CHANGE NOTIFICATION

Dear Sir/Madam: PCN# 052813

Subject: **Notification of Assembly Process Change for LTM8021 and LTM8031**

LTM8021- Current and New Design

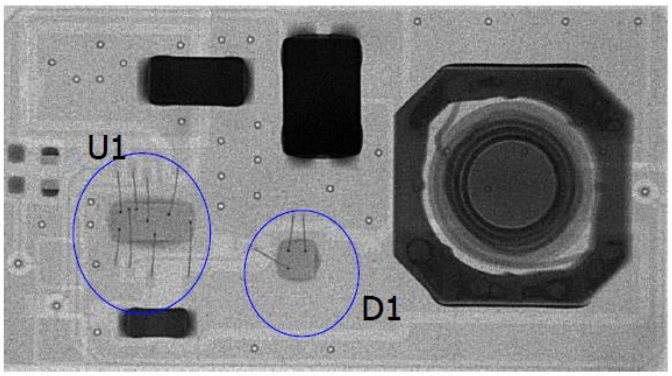
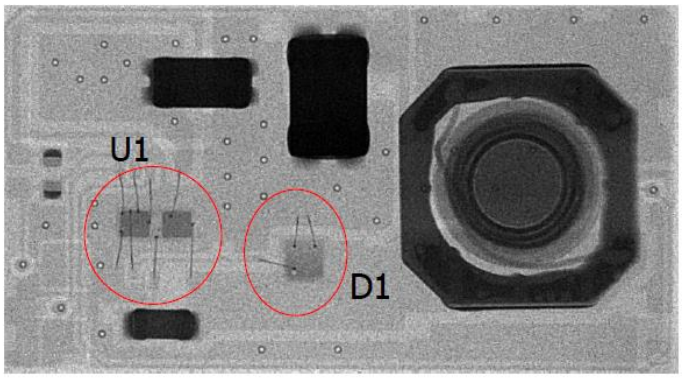
Please be advised that Linear Technology Corporation has made a minor change to the internal package construction to facilitate the use of one attach material for both die and components. The die attach material is changed from epoxy to solder, which is already used for attaching components in the same µModule device package. In order to use the solder die attach, the die attach paddle (DAP) has been modified by splitting the DAP into multiple pads for dice D1 and U1. Linear has been shipping several µModule devices using solder for die attach and component attach.
